MIAMI BEACH

Staff Report & Recommendation

Design Review Board

SUBJECT: DRB23-0956
1901 Alton Road – Whole Foods

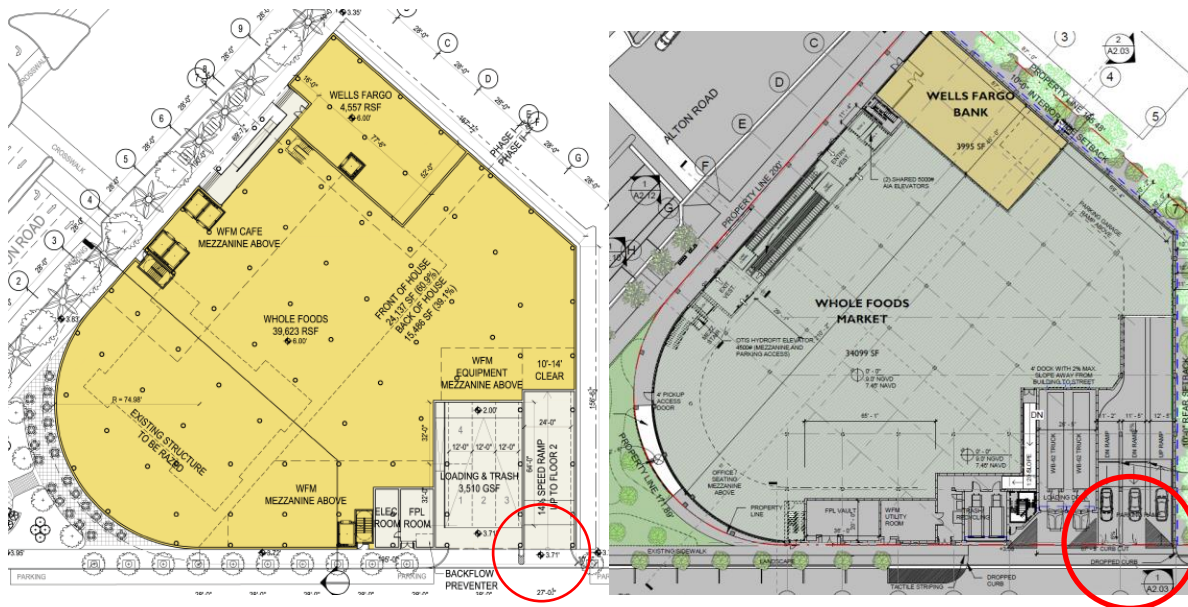
Staff compared the proposed site plan with the plan approved in 2015, and the following is noted:

2015 Approval:

Current proposal:

2 Car driveways
 3 Loading driveways

3 car driveways
 2 Loading driveways
 2 Trash compactors driveways

During the pre-application process, staff expressed serious reservations to the applicant regarding the driveway configuration proposed in comparison to the configuration approved in 2015 and recommended the removal of one of the car exit driveways, as well as reductions in the loading and trash compactor areas, to improve the pedestrian experience along 19th Street. Since the applicant has a surplus of parking on levels 3 to 4, double driveways could be accommodated on the second level to prevent queuing when exiting.
